P802.3bt D3.0 – Dual-signature LLDP v141

This is an overhaul for the LLDP specification in Clause 79, specifically addressing dual-signature operation. It aims to address the issues raised in comments #130, #293, #294, #296, and #297.

Figure 145–39—PSE power control state diagram for single-signature PDs

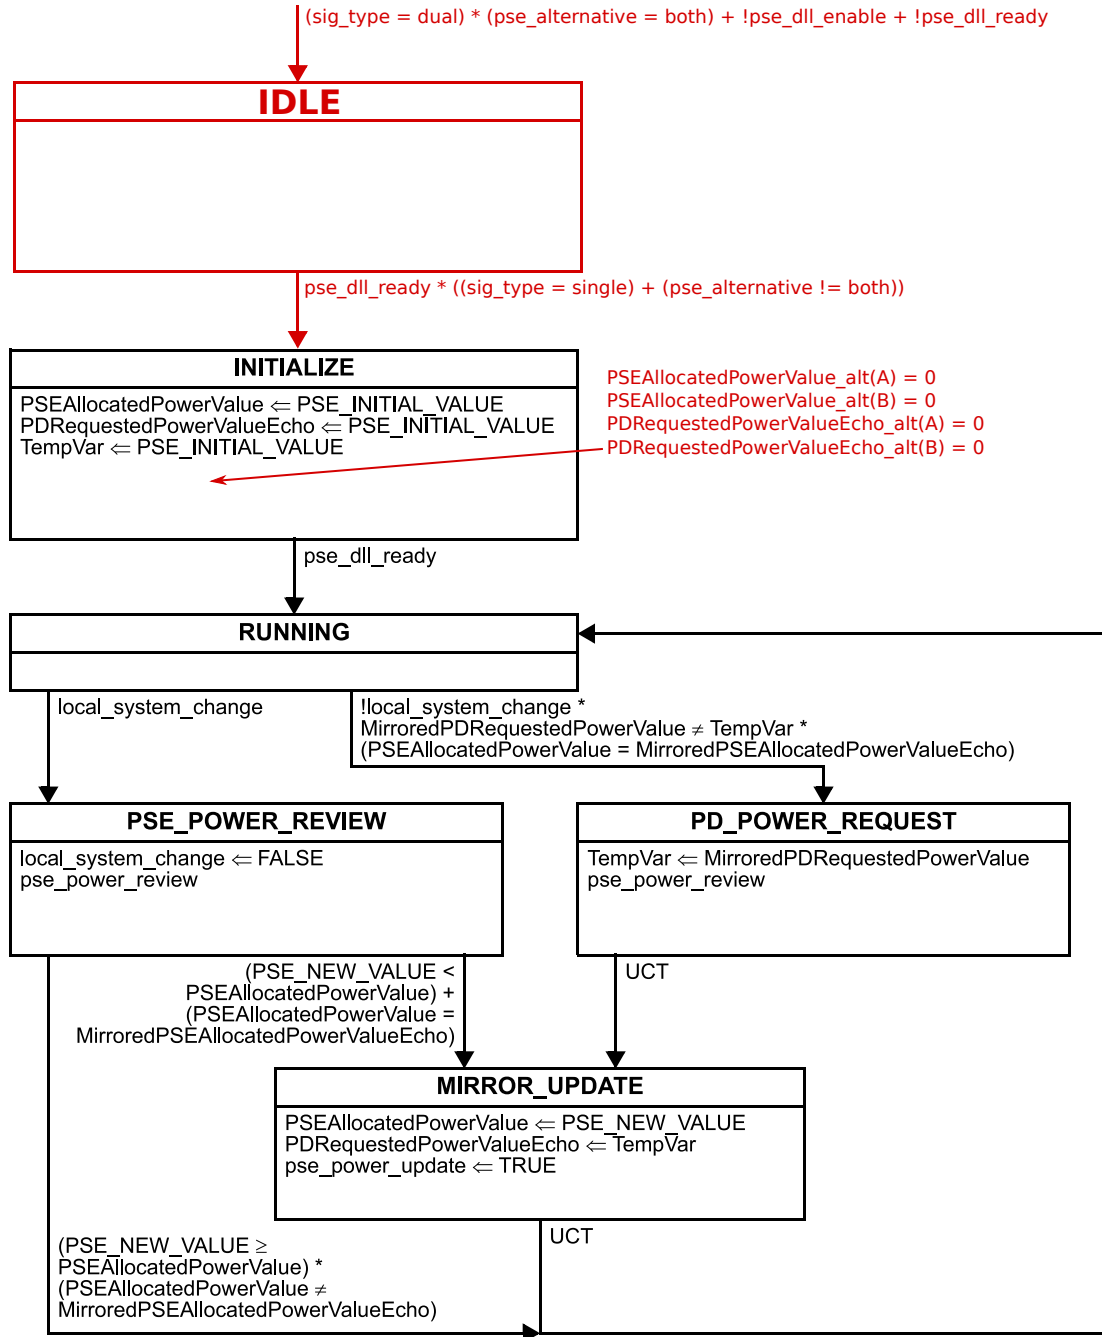
This is one of the three state diagrams that the PSE needs to run. It sits in IDLE whenever DLL isn't enabled or not ready, or when the other state diagrams need to be in control (dual-signature detected). It proceeds to INITIALIZE when DLL is ready and the PD is a single-signature, or the PSE is restricted to 2-pair operation.

Change Figure 145–39 as follows:

This state diagram controls the PSEAllocatedPowerValue variable, which is used to allocate power to a PD. This variable and the corresponding LLDPDU field is used for power allocation when the PD is a single-signature PD, or when the PD is supplied in 2-pair mode.

Figure 145–41—Single-signature PD power control state diagram

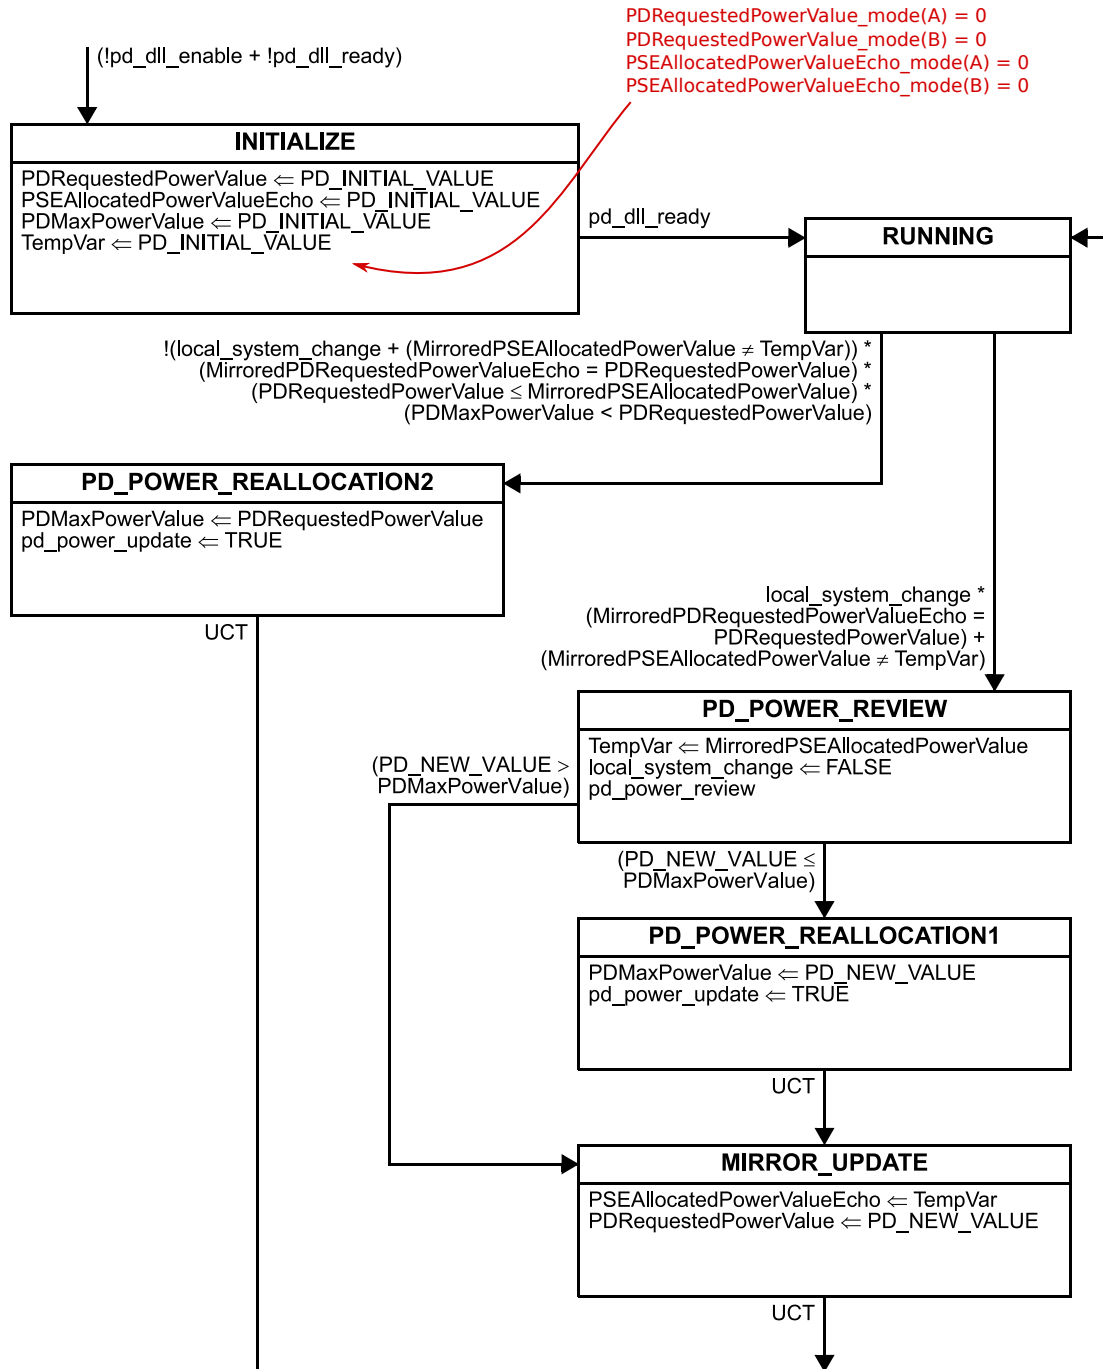
This is the state diagram for single-signature PDs. By setting the A/B fields to zero in INITIALIZE we have made this state diagram self-sufficient for single-signature. The other state diagrams intended for dual-signature do not need to run (as reflected in the text earlier).

Change Figure 145–41 as follows:

This state diagram controls the PDRRequestedPowerValue variable, which is used to request power from a PSE, when the PD is a single-signature PD, or when the PD is supplied in 2-pair mode.

Figure 145–43—PSE power control state diagram for dual-signature PDs in 4-pair mode

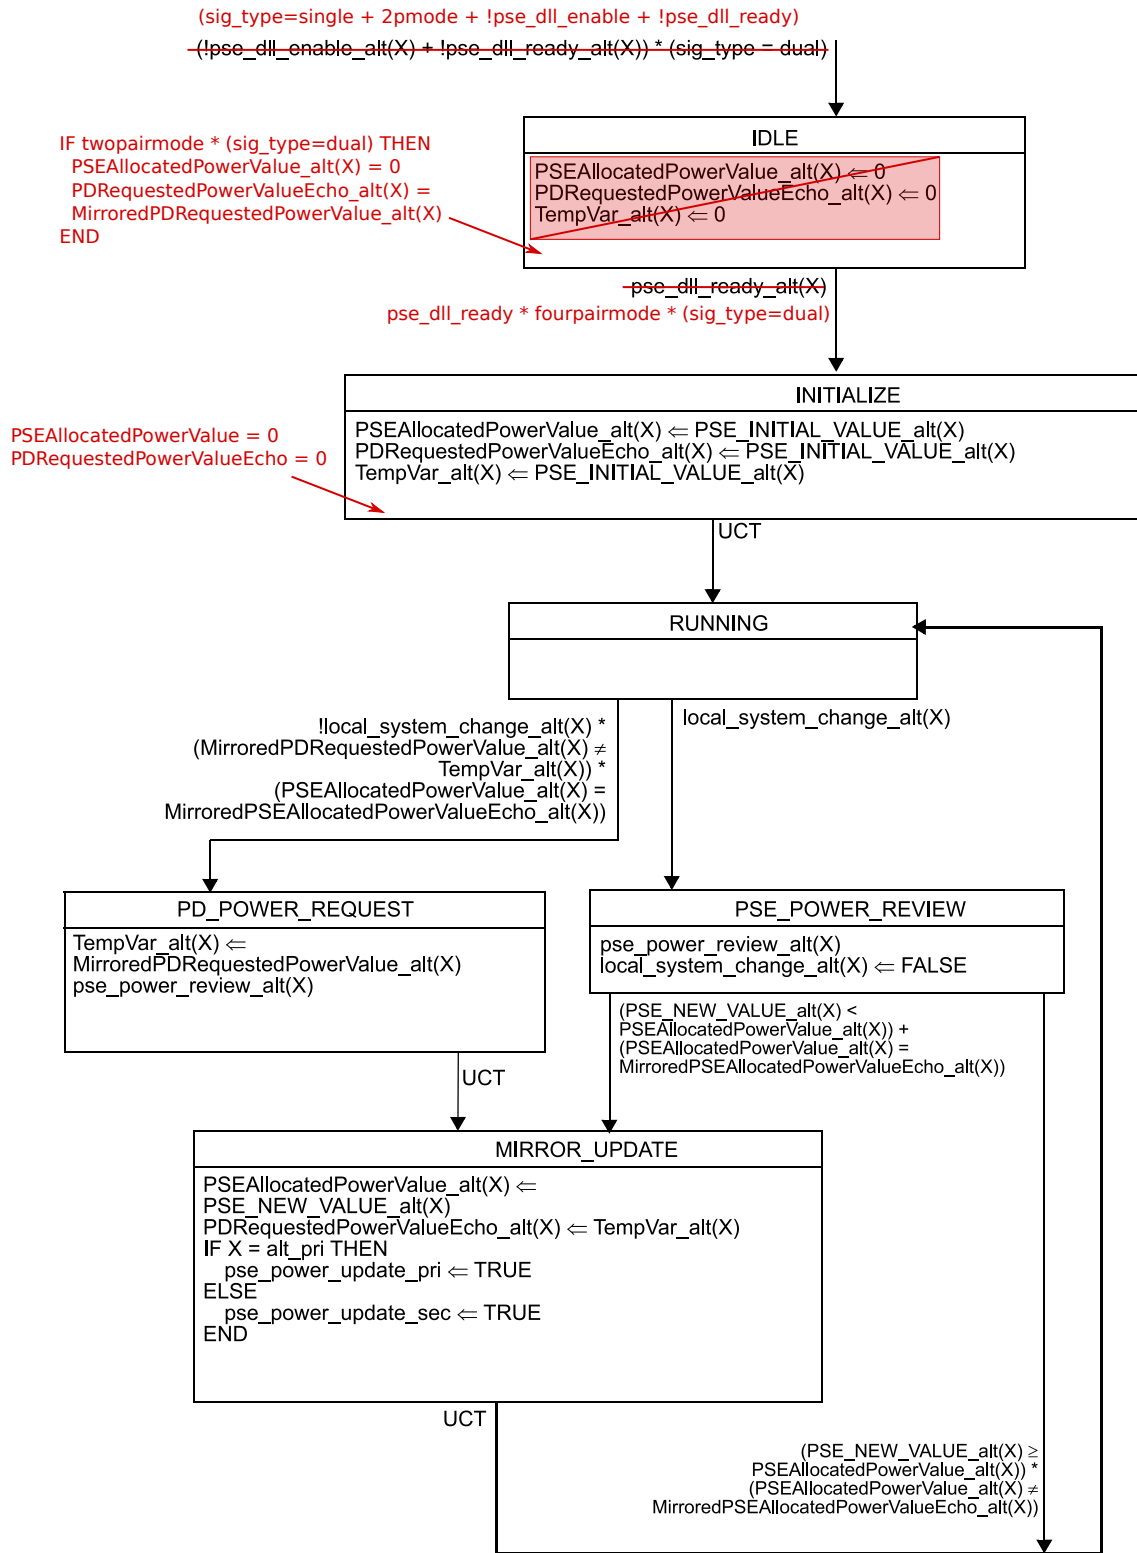
Change Figure 145–43 as follows:

This state diagram controls the PSEAllocatedPowerValue_alt(X) variables, which are used to allocate power to the

individual Modes of a dual-signature PD. These variables and the corresponding fields in the LLDPDU are used for power allocation when the connected PD is a dual-signature PD that is supplied in 4-pair mode.

Figure 145–43a—PSE power control state diagram for dual-signature PDs in 2-pair mode

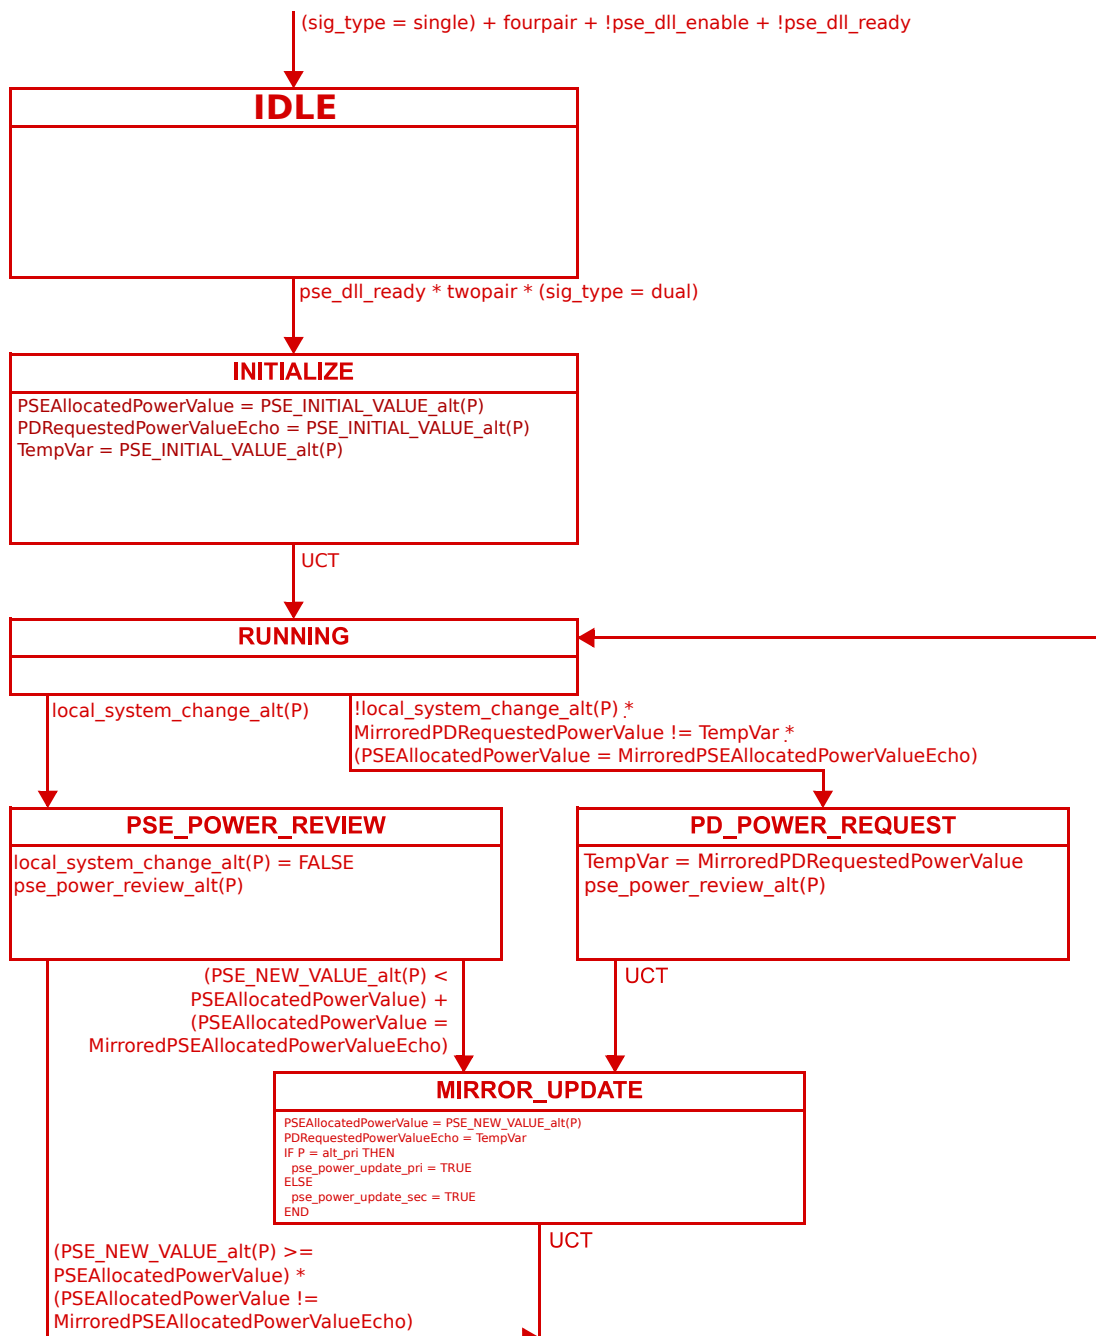
Insert Figure 145–43a as follows:

Figure 145–44—Dual-signature PD power control state diagram for 4-pair mode

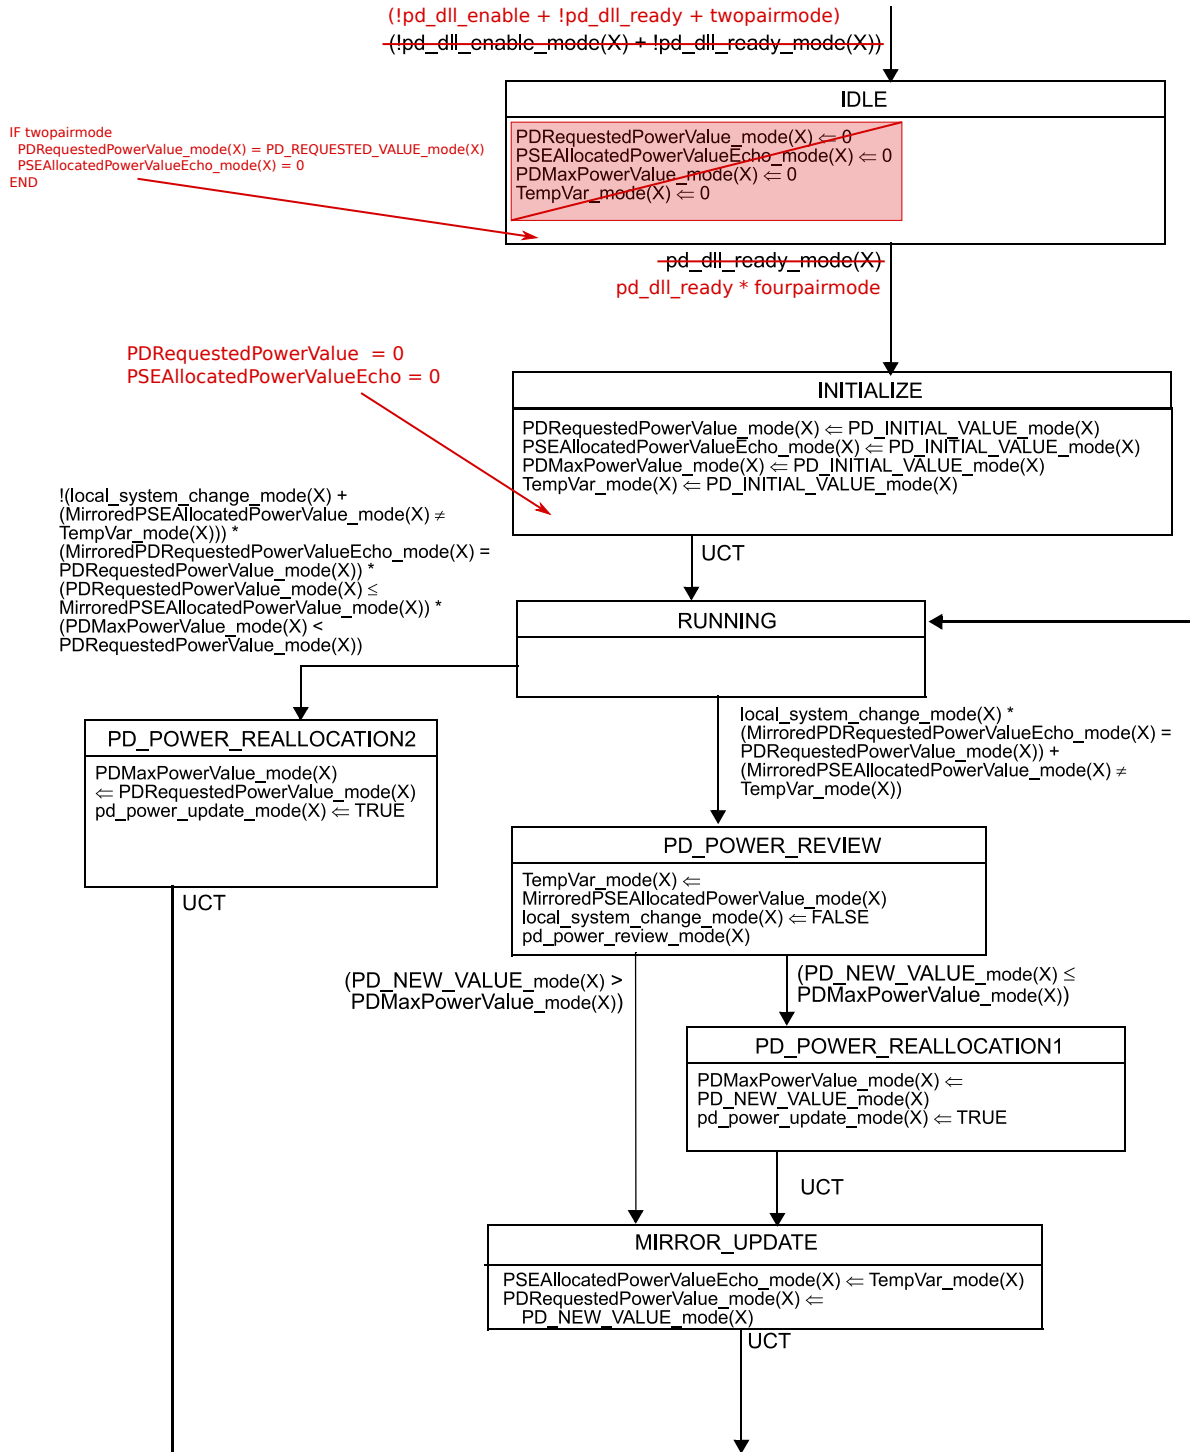
Change Figure 145–44 as follows:

This state diagram controls the PDRequestedPowerValue_mode(X) variables, which are used to allocate power to the individual Modes of a dual-signature PD. It is applicable when the PD is a dual-signature PD that is supplied in 4-pair mode.

Figure 145-44a --- Dual-signature PD power control state diagram for 2-pair mode

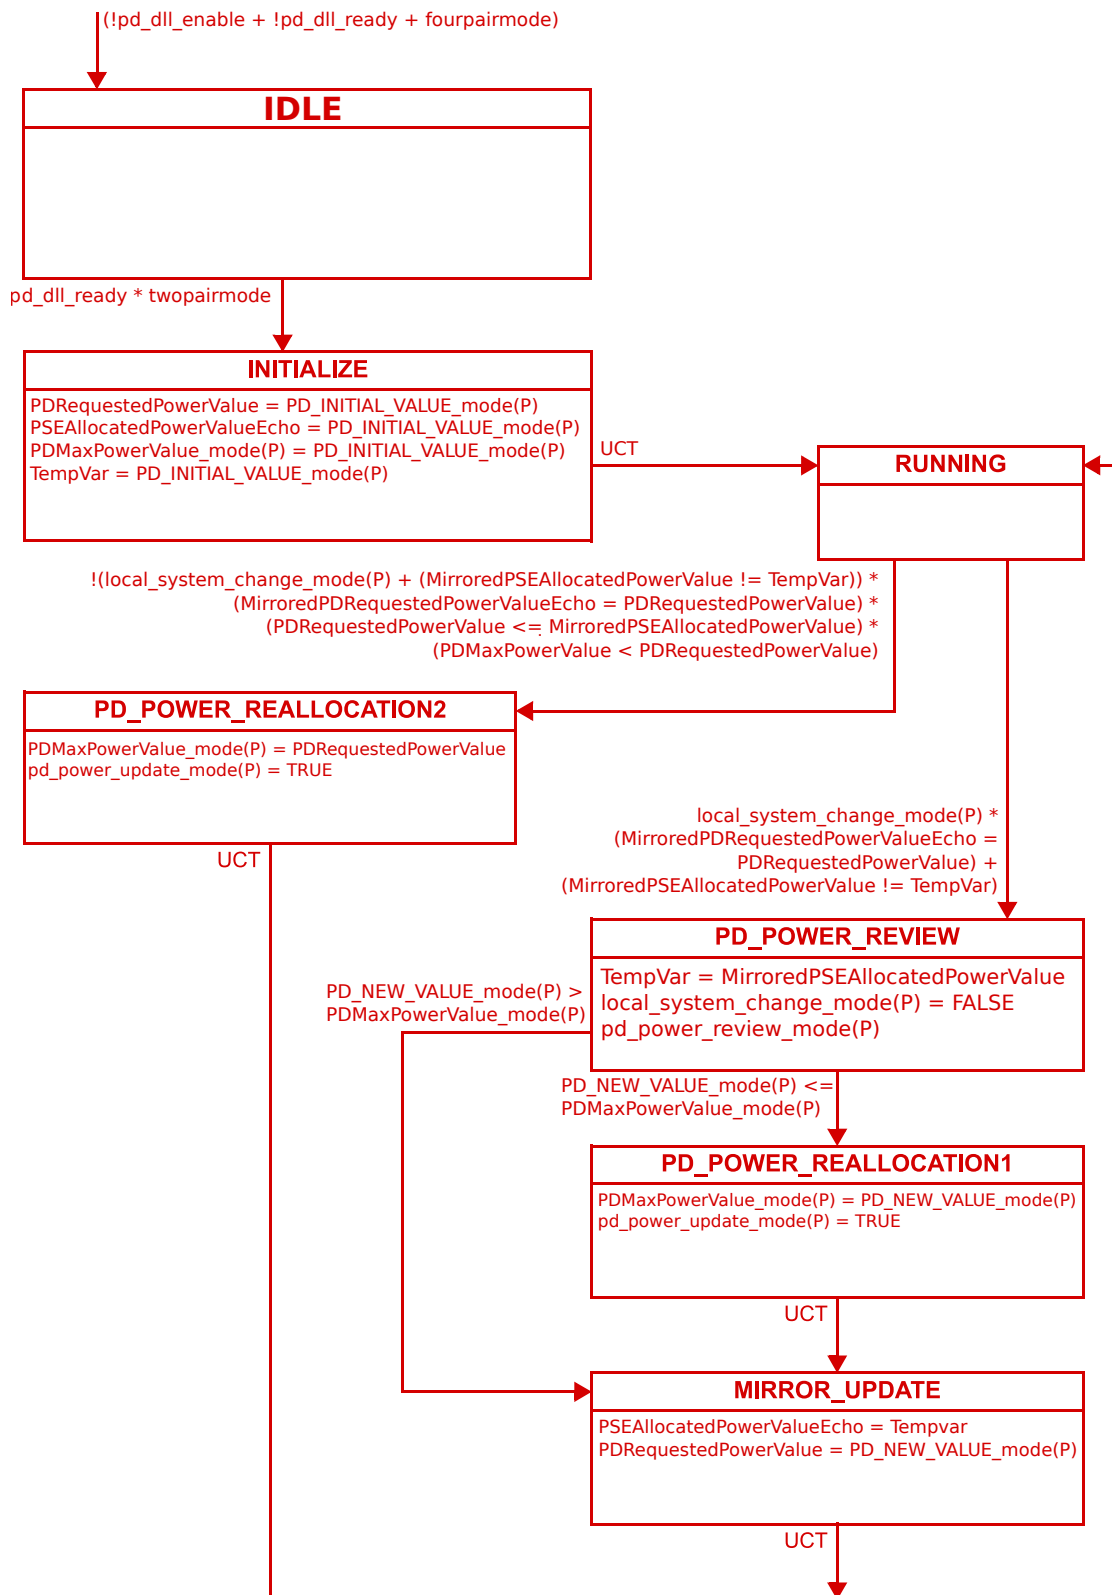
Insert Figure 145-44a as follows:
